PREVOST

Warranty Bulletin

96-27A

Date: **November 1996**
Section: **18**
Subject: **DEFORMATION OF ALUMINUM SIDE PANELS**
Application:

FIGURE 1: BAR ON ALUMINUM PANEL

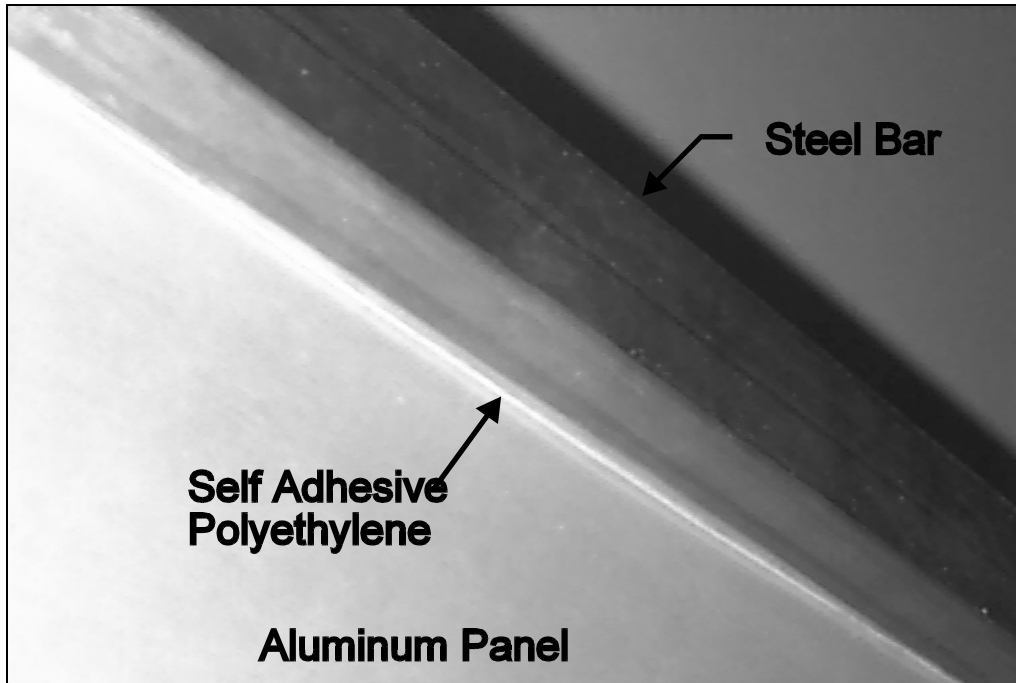
3. Glue self adhesive polyethylene on one of the widest sides of steel bars. Properly position steel bars making sure polyethylene coated side goes on aluminum panels (Fig. 1).

FIGURE 2: LOCATION OF BARS

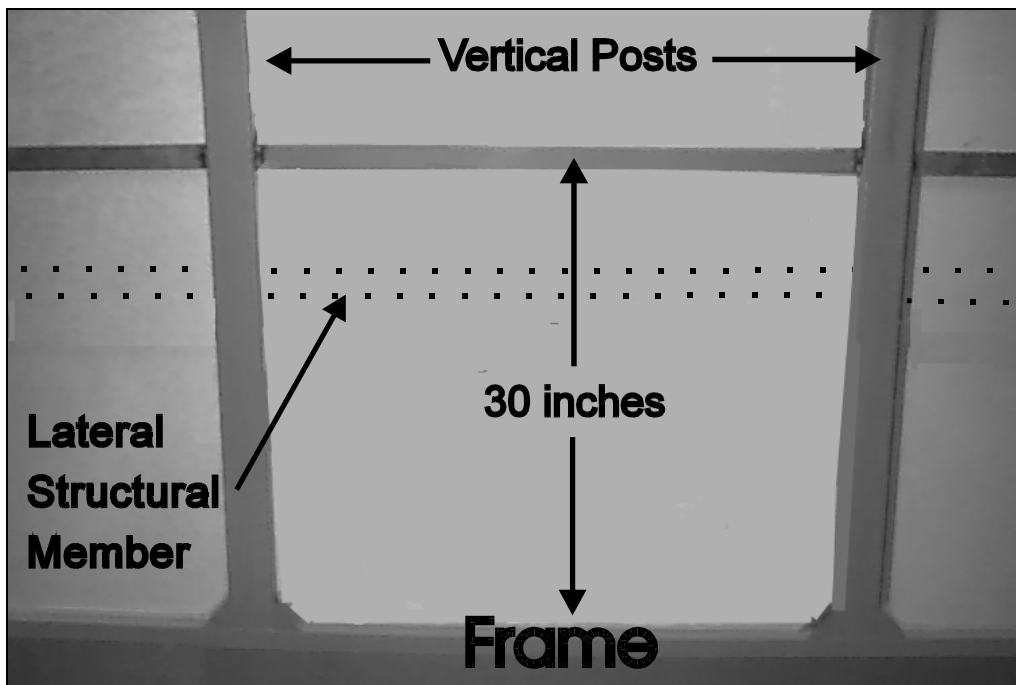
Note: Bars are welded at a height of 30 inches from frame (Fig. 2).

FIGURE 3A: LOCATION OF WELD RUNS

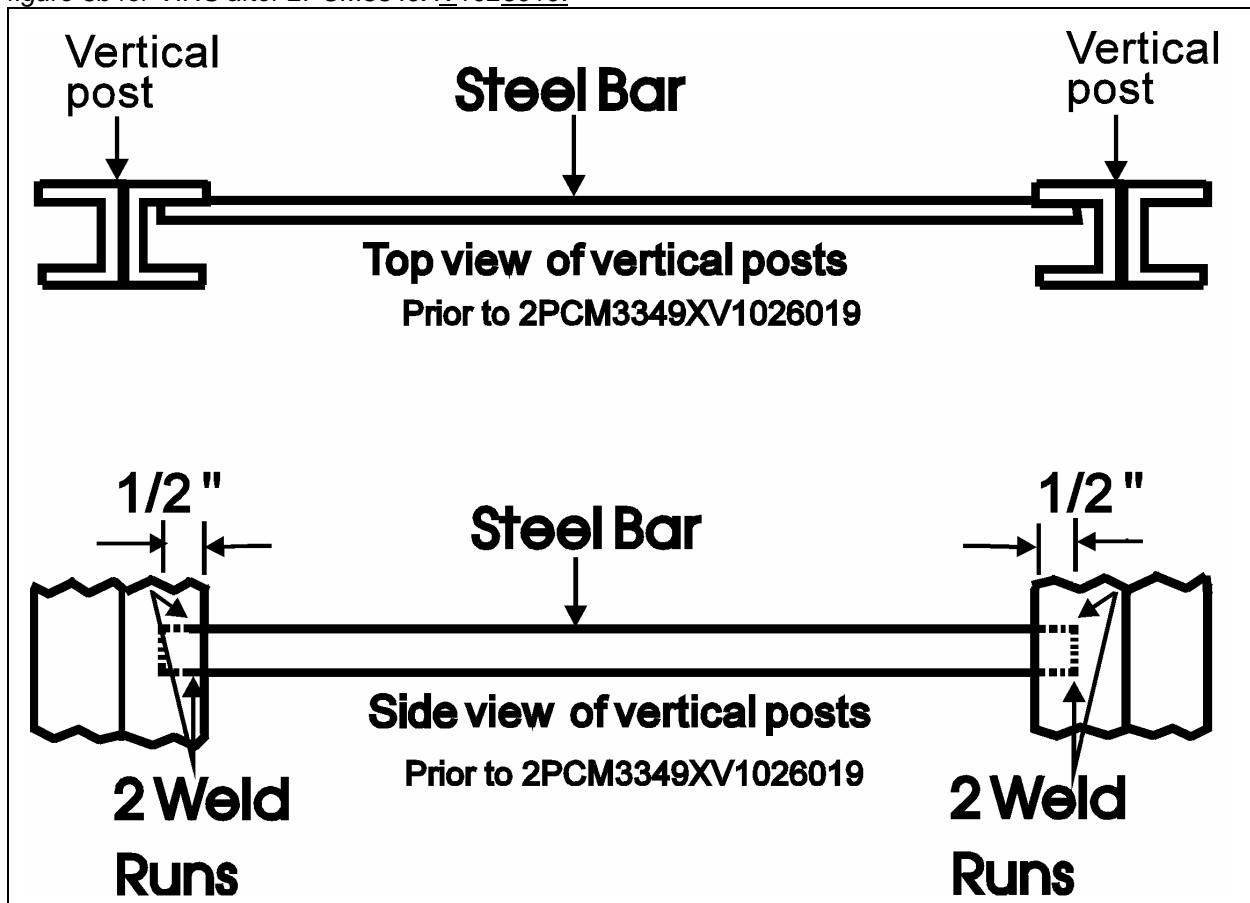
Note: For VINS prior to 2PCM3349XV1026019, steel bar is 1" longer than for subsequent VINS (Fig. 3a).

4. Grind steel bars extremities and vertical posts at weld locations.
5. Weld steel bars to vertical posts as shown in figures 3a and 3b.

Note: Figure 3a shows steel bar/vertical posts for VINS prior to and including 2PCM3349XV1026019 and figure 3b for VINS after 2PCM3349XV1026019.

FIGURE 5: LOCATION OF URETHANE PANELS

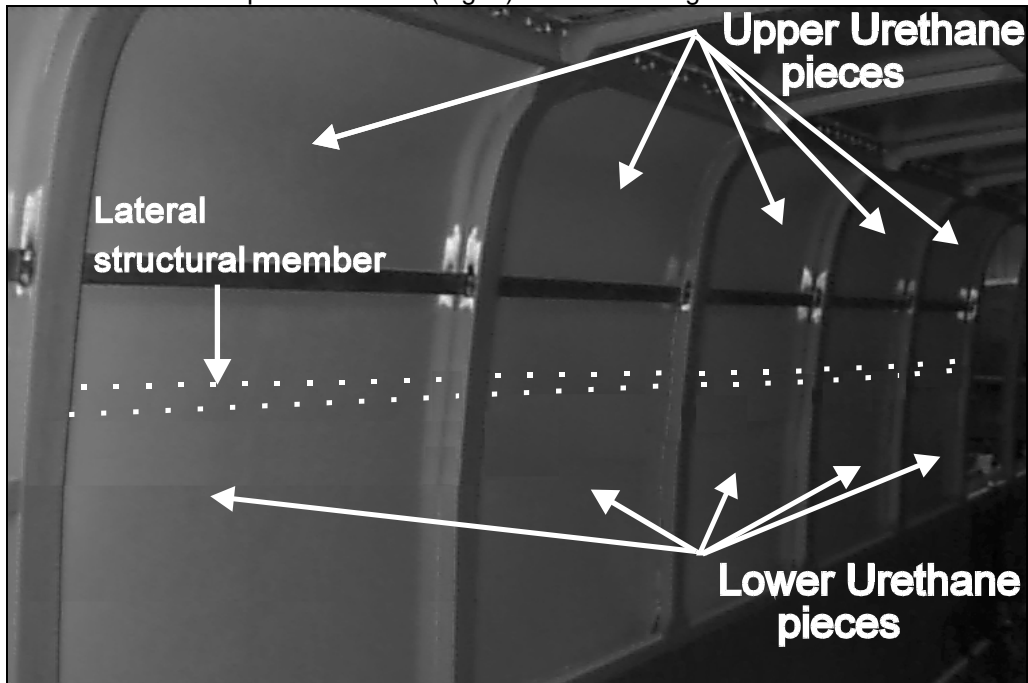
-
6. Glue urethane insulation panels to walls (Fig. 4). Use contact glue.
